Watts Bar Nuclear Plant, Unit 2  
NRC Docket No. 50-391

**Subject: Watts Bar Nuclear Plant (WBN) Unit 2 – Safety Evaluation Report  
Supplement 22 (SSER22) - Response to NRC Required Action Items**

### Response to Action Items From Appendix HH of NUREG-0847, Supplement 22

FIGURE 1  
WATTS BAR UNIT 2, CYCLE 1  
REFERENCE CORE LOADING PATTERN

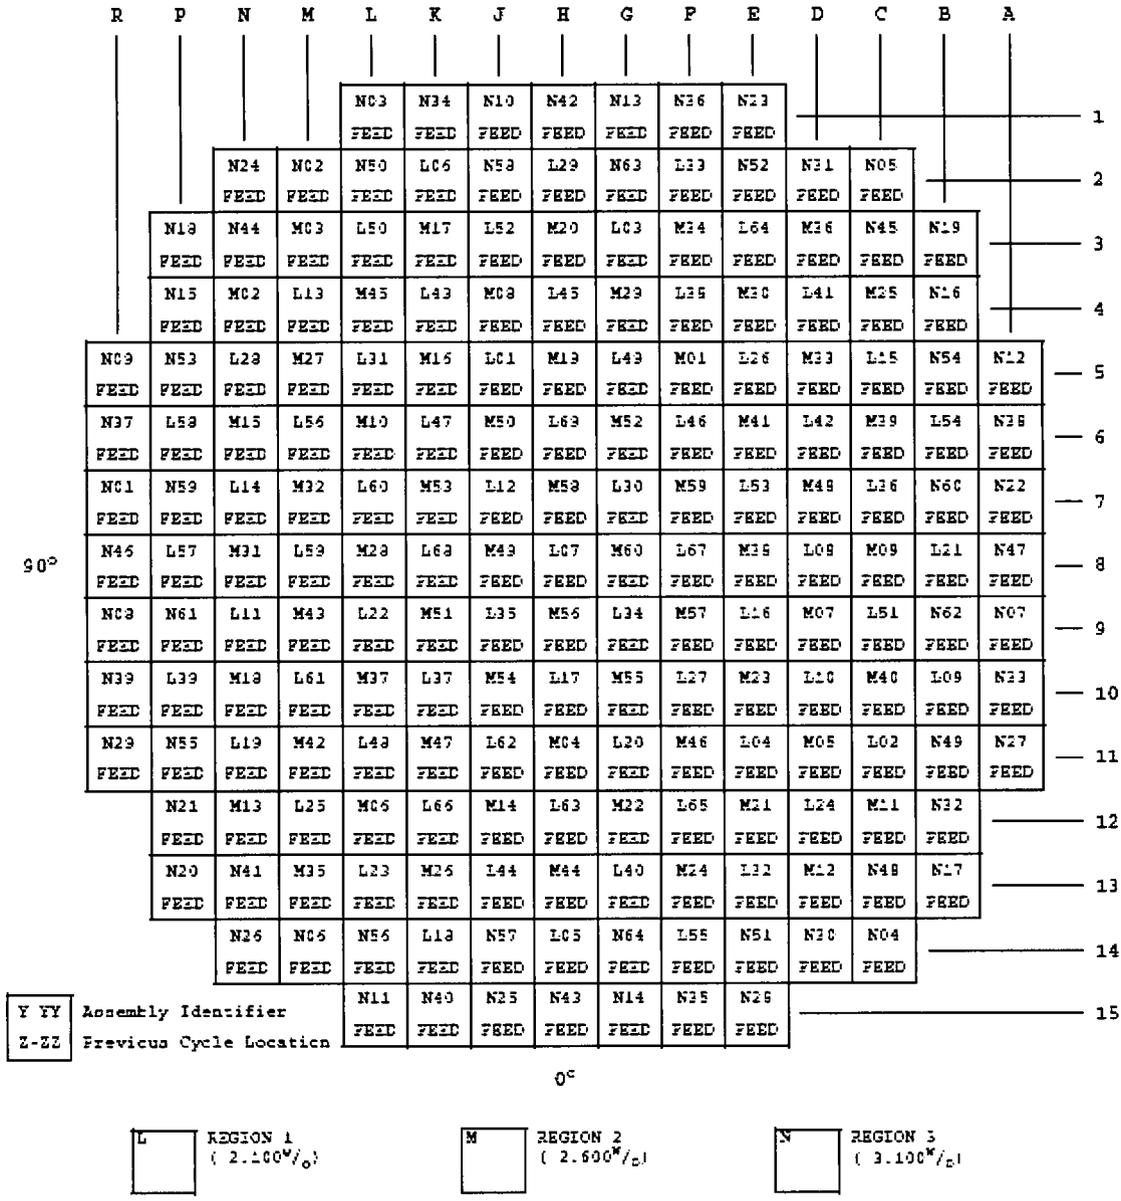
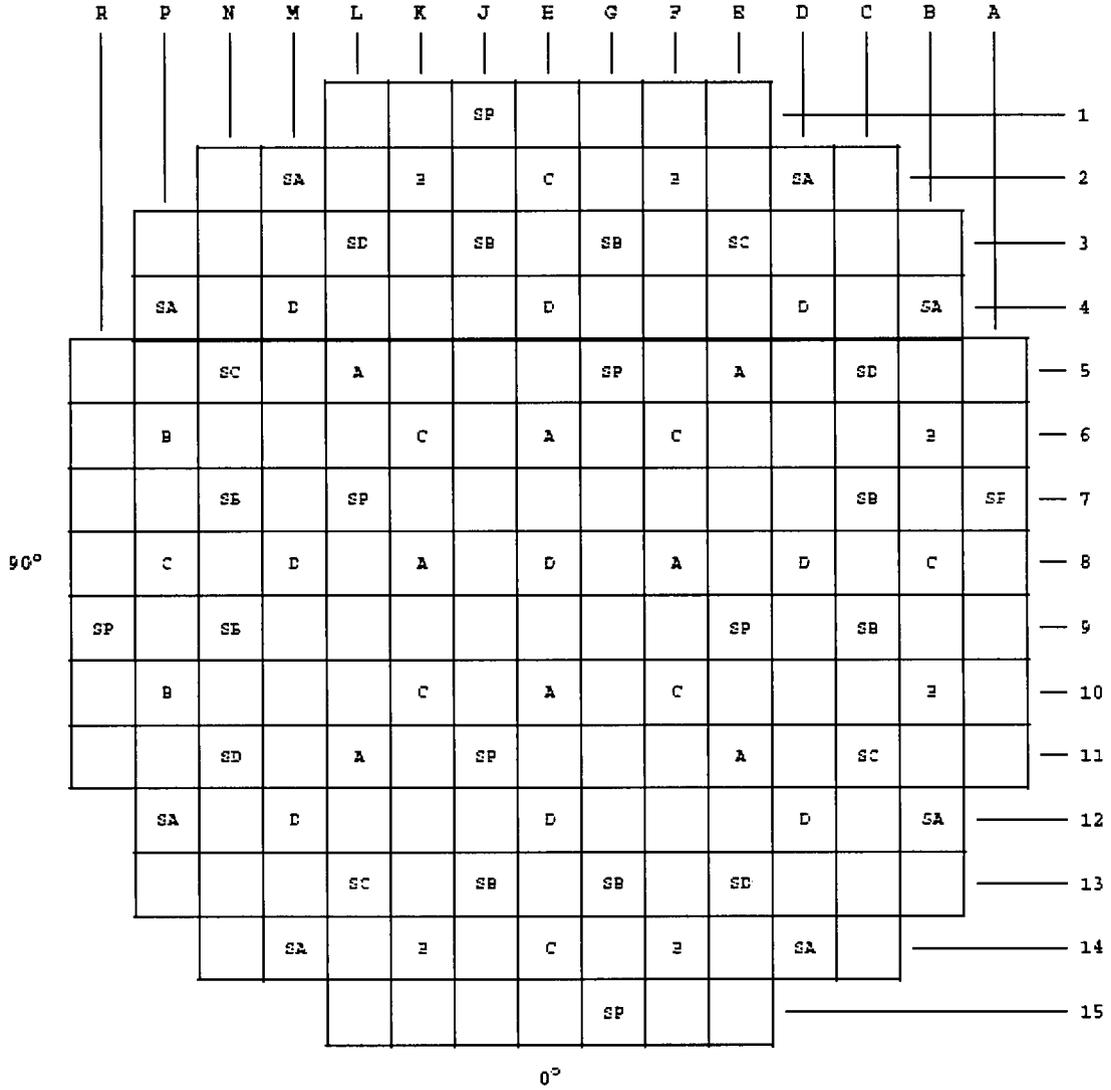
8. *Verify rod control system operability during power ascension. TVA should provide a pre-startup map to the NRC staff indicating the rodded fuel assemblies and a projected end of cycle burnup of each rodded assembly for the initial fuel cycle 6-months prior to fuel load. (NRC safety evaluation dated May 3, 2010, ADAMS Accession No. ML101200035)*

**Response:** Attachment 1 provides the requested pre-startup map indicating the rodded fuel assemblies and the projected end of cycle burnup of each rodded assembly for the initial fuel cycle.

Figure 1 provides the core loading pattern for WBT01, while Figure 2 provides the control and shutdown rod locations. Figure 3 provides assembly average burnups for all core locations, at the maximum analyzed Cycle 1 burnup (17675 MWD/MTU).
